ISC-C1 Rack

Title		
ISC System Wiring Diagram		
Size	Number	Revision
B	D1900511	V6
Date:	10/06/2021	Sheet of 1 38
File:	C:\Users\...ISC_C1_SH1.SchDoc	Drawn By: Filiberto Clara

Title		
Squeezer RF Distribution		
Size	Number	Revision
C	D1900511	V6
Date:	10/06/2021	Sheet of 32 38
File:	C:\Users\...SqueezerRfDistribution.SchDxDrawn By: R. Abbott

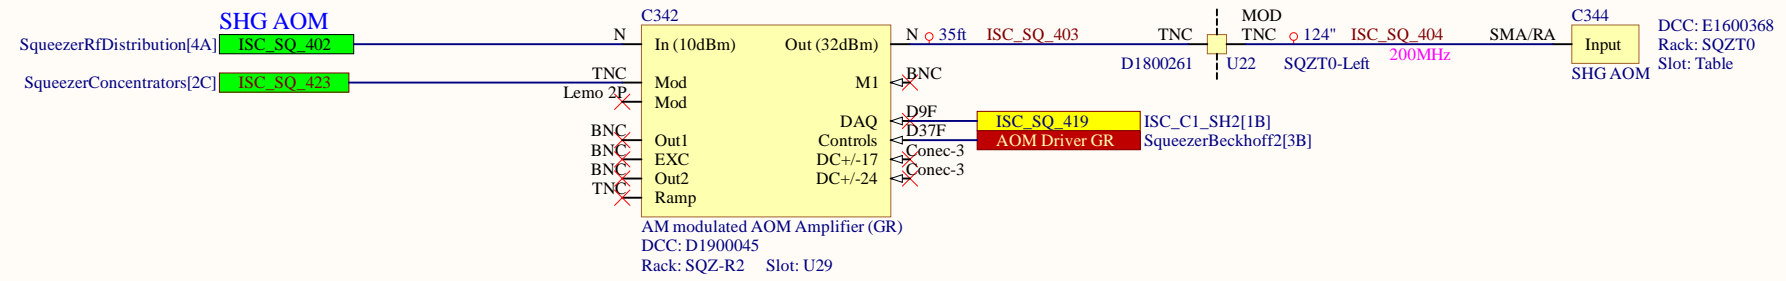
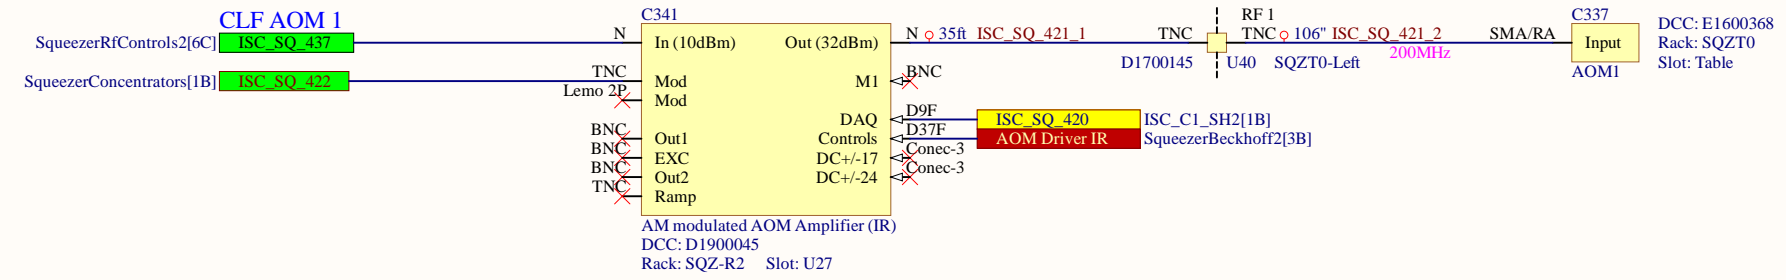
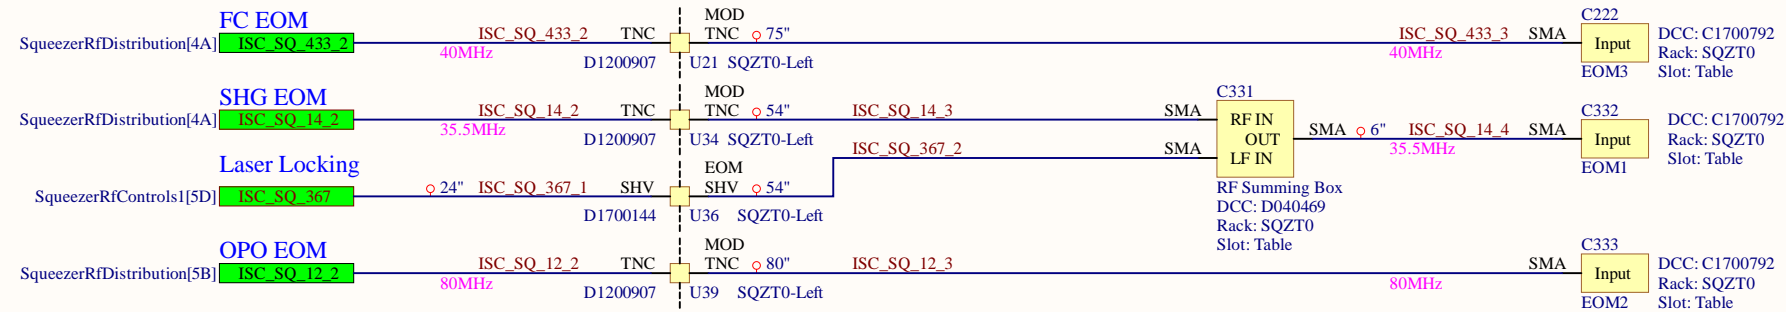
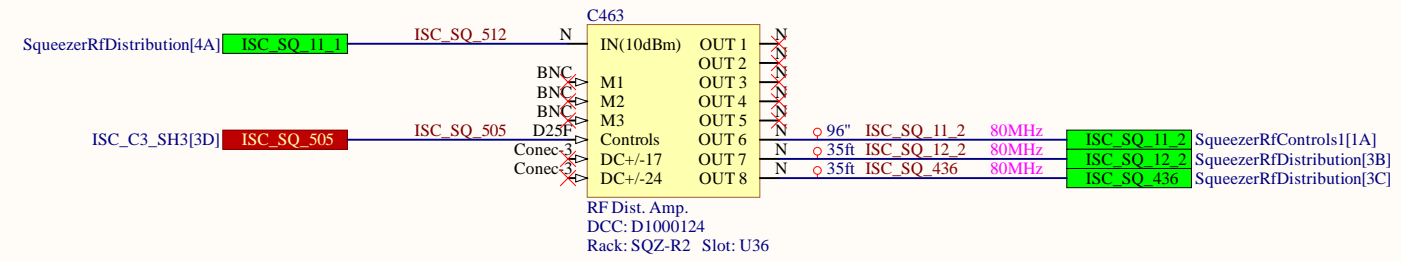
New cables for A_ start at ISC_SQ_430

Part Number??

RF cables carrying the AOM signals need to be 1/4" superflexible helical corrugated coax.
